# South Coast Air Quality Management District

February 22, 2023

**Draft Program Environmental Impact Report (Draft PEIR) for the Proposed  
Airport Gateway Specific Plan (Proposed Project)  
(SCH No. 2022060349)**

**Figure A**  
**Process Map of Proposed Project<sup>50</sup>**

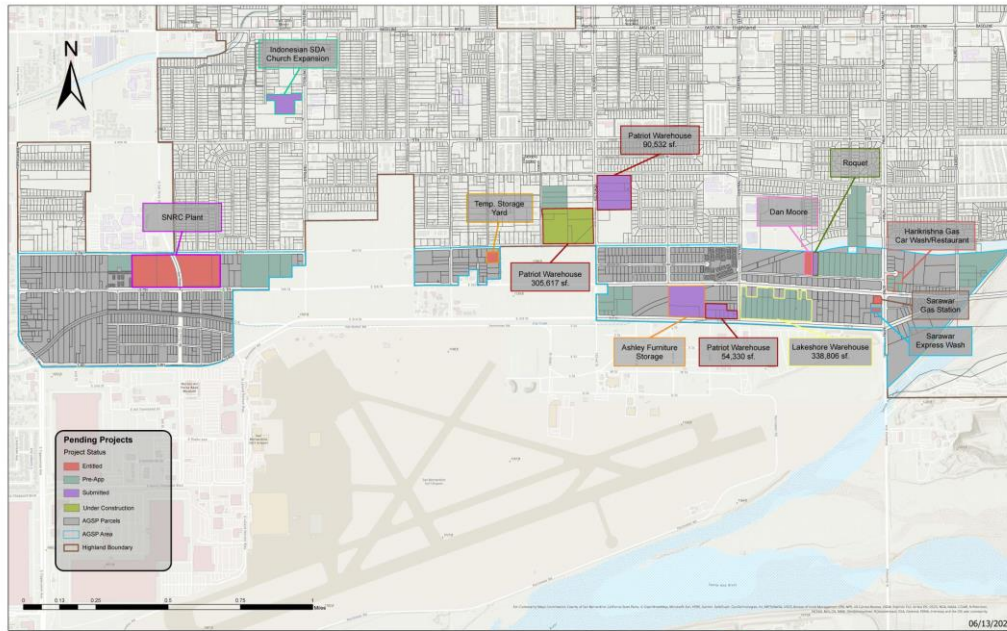
Based on the Draft PEIR, the Lead Agency provides a map of pre-app, submitted, entitled, and under-construction projects in Figure 6.2-1;<sup>47</sup> and reveals one entitled project that draws South Coast AQMD staff's attention, which is the Sterling Natural Resource Center (SNRC) Plant listed in Table B. Based on Figure 6.2-1 in the Draft PEIR, this SNRC Plant is located within the Proposed Project planning area. However, under Appendix 8.4 – Draft AGSP,<sup>48</sup> the Proposed Project boundary does not include the SNRC Plant.<sup>49</sup> South Coast AQMD has captured Figures A and B below to show the inconsistency related to this SNRC Plant.

Due to the inconsistency related to the location of the SNRC Plant, South Coast AQMD staff has recommendations for the two scenarios that can occur, which are discussed below.

In the event that the SNRC Plant is located within the Proposed Project planning area, the Lead Agency might have underestimated the construction and operational emissions, as the emission generated from the SNRC Plant (including the flare and biogas engines) should be added to the emissions analysis in this Draft PEIR. Therefore, South Coast AQMD staff recommends that the Lead Agency revise the emissions analysis, determine the significance level, propose feasible mitigation measures to reduce the emissions further, and disclose the results in the Final PEIR. In addition, the SNRC Plant should also be included in the construction and operational HRAs (refer to the South Coast AQMD staff's HRA comment), with the result disclosed in the Final PEIR. If the revision is not included in the Final PEIR, the Lead Agency should provide reasons for not having them supported by substantial evidence in the record.

In the event that the SNRC Plant is located outside of the Proposed Project planning area, the Lead Agency should consider adding this SNRC Plant to the cumulative impacts analysis discussion (refer to South Coast AQMD staff's comment on cumulative impacts analysis) and include it in the Final PEIR. If the revision is not included in the Final PEIR, the Lead Agency should provide reasons for not having them supported by substantial evidence in the record.
